UNITED STATES PATENT AND TRADEMARK OFFICE

APPLICATION NO.	FILING DATE	FIRST NAMED INVENTOR	ATTORNEY DOCKET NO.	CONFIRMATION NO.
10/694,054	10/28/2003	Keiichi Kunimoto	740737-282	3885

Office Action Summary

DETAILED ACTION

FIG. 1

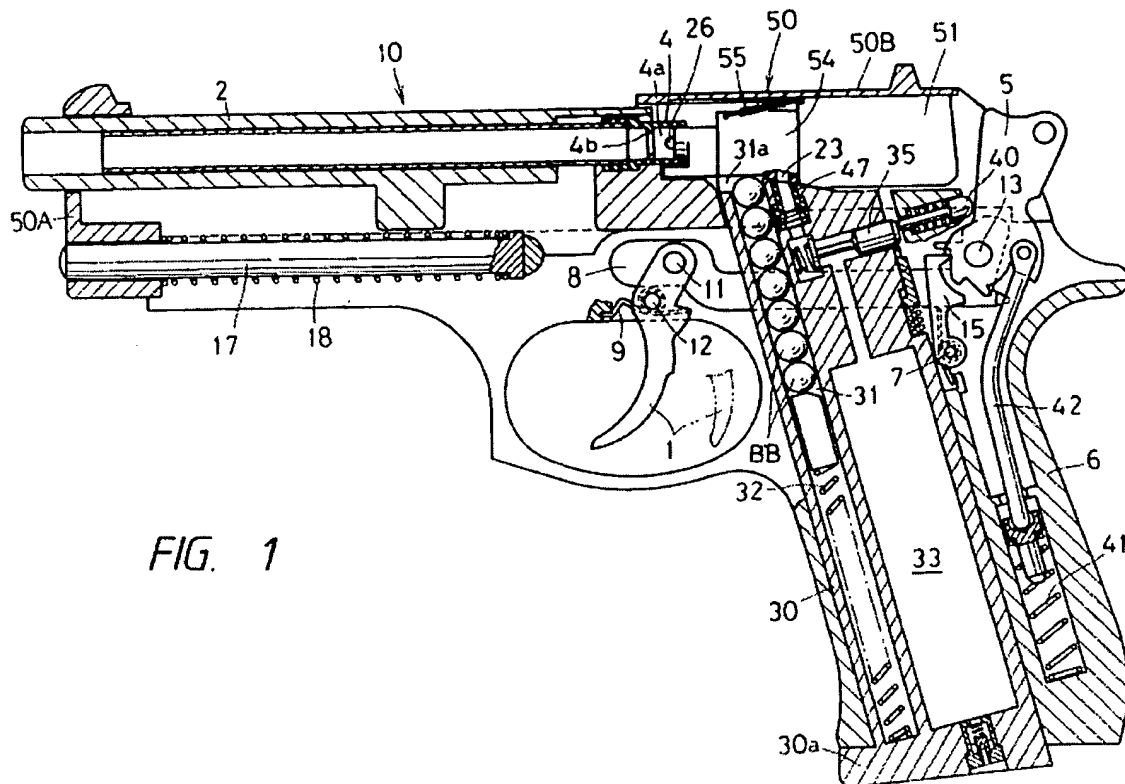
4. Claims 1-3, 5 and 6 are rejected under 35 U.S.C. 102(b) as being anticipated by US 5476087 issued to Kunimoto.

5. With respect to claim 1, Kunimoto discloses a toy gun comprising:

- a. a frame 10
 - i. barrel 02
 - ii. loading chamber 4a
 - iii. trigger 01;
- b. a movable member 51
 - iv. pressure receiving portion 51A
- c. driving mechanism 05
- d. gas supply controller 35, 36, 37, 40

- e. a gas passage forming member 54
- v. 1st gas passage 21
- vi. 2nd gas passage 51B
- f. movable valve 27
- vii. valve operation col. 9, l. 62 to col. 10, l. 46.

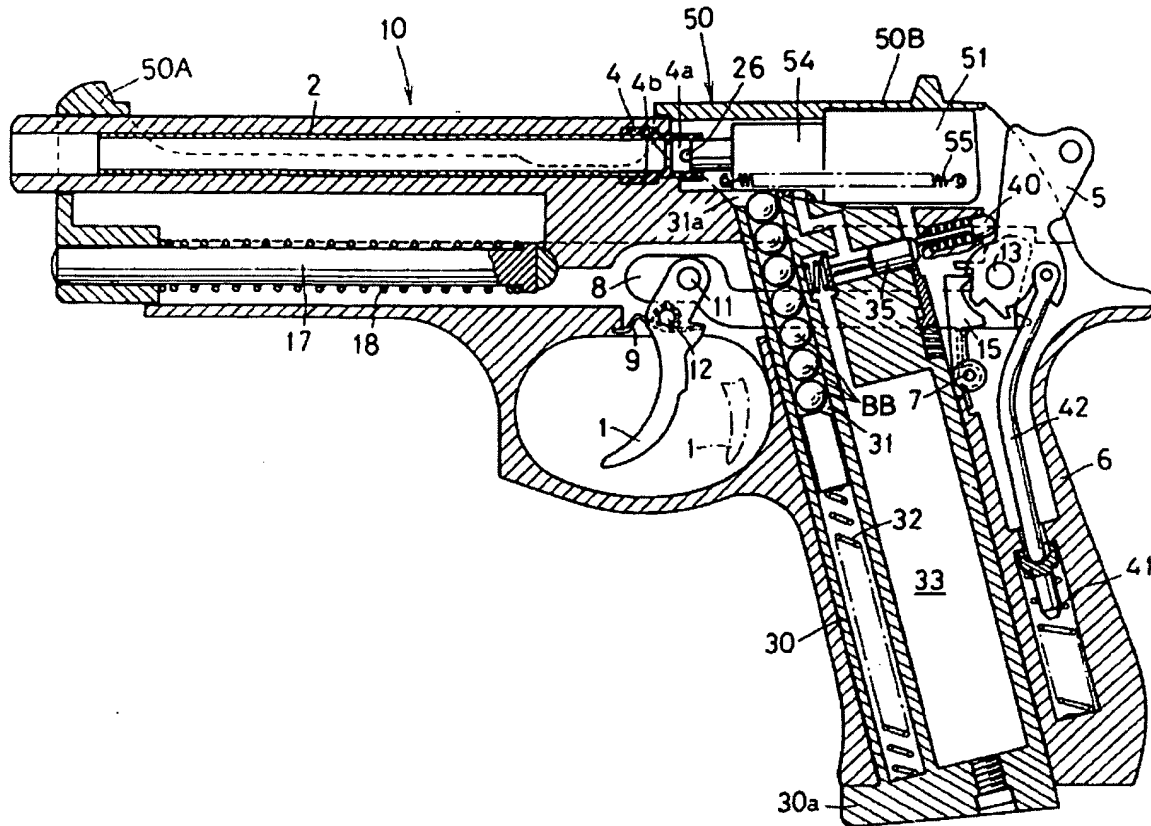
6. With respect to claim 2, the applicant recites, “objects *to be held* in the magazine are paint containing bullets.” Claimed elements that are “to be held” are not positively recited and, therefore, do not recite limiting structural features.

7. With respect to claim 3, the device as disclosed by Kunimoto inherently performs the claimed functions.

8. With respect to claims 5 and 6, Kunimoto discloses:

- g. a gas/accumulation chamber 33
- h. control valve 35.

FIG. 1

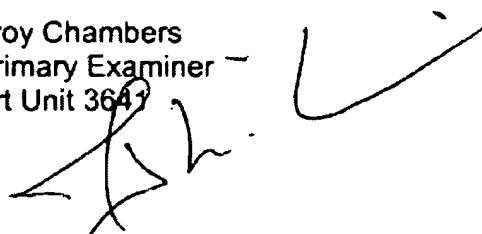
9. Claims 1-3, 5 and 6 are rejected under 35 U.S.C. 102(b) as being anticipated by US 5477843 issued to Kunimoto. The ‘843 has the same or similar relevant structure similar to that of the ‘087 patent as shown below.
